All modifications listed here refer to the PCB Revision 0.4

DF8OE, 06/20/2016

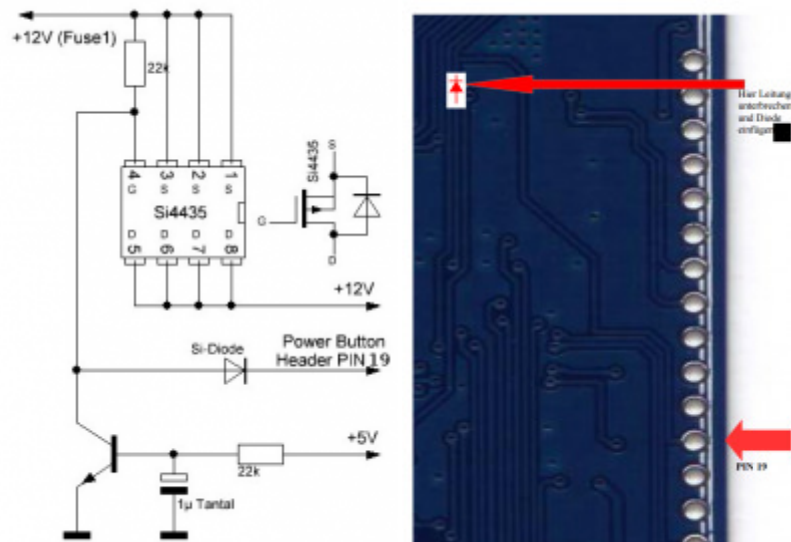
- (RF-04-N-009) The two gate resistors R81 and R82 were of 220R reduced to 100R (only if the amplifier at high output current fluctuation has).
- (RF-04-N-010) At high speaker volume, the ripple of the 8V supply voltage coupled to the receiver mixer. Why does the LF amplifier attached to the stabilized voltage as well? I have it connected with a FET connected directly to the 12V input voltage. This current changes will affect at high volume no longer to receive. Additionally, I have connected with this switched 12V input of 8V voltage regulator and the two voltage divider elements directly to the 12V. As a result, the quiescent current consumption in "off" mode is now fallen to less than 1uA. The following changes are necessary:

- On the ui board is the line "PC13" excoriated by the processor to the power switch and the header below the LCD and placed a diode in this line (anode to the processor out)

- On the rf board Pin4 is from U3 highly placed as well as the sides of R9 and R13, which will go to 12V. These three connectors are now merged with wire and attached to SW_12V the new circuit.

- The rest will be seen from the unique labels of the new circuit is wired. On the right, the place can be seen where the additional diode is installed. The site is located on the ui board below the LCD. The cathode of the diode is then in the picture above and below the anode (for STM32F4 out).

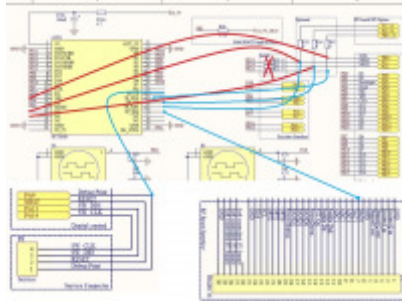
- (UI-04-N-026) If you want to activate the touch screen capabilities, has embarrassed five wires and R30 ... R32 unsolder (when the are loaded). The pin names are at the bottom of the LCD panel, I use these designations - the wires are laid but on the UI board itself. The wires do not interfere with the function of MCHF, even if the firmware does not yet support the touch screen! TP_IRQ hits the header Pin7 (== PA4 MCU), TP_SDO goes to the common terminal of R30 and R33, TP_SDI goes to the common terminal of R31 and R34, TP_SCK goes to the common terminal of R32 and R35 and TP_CS goes pin 1 of P8 (== PO9 the MCU). From the testing firmware 0.219.26.13 the touch screen is supported. Please note that the red wires are NOT necessary for the function of the touch screen. These wires are for the operation of the LCD in SPI mode required (UI-04-N-025). If one makes the touchscreen modification, it makes sense to do this modification with the same.
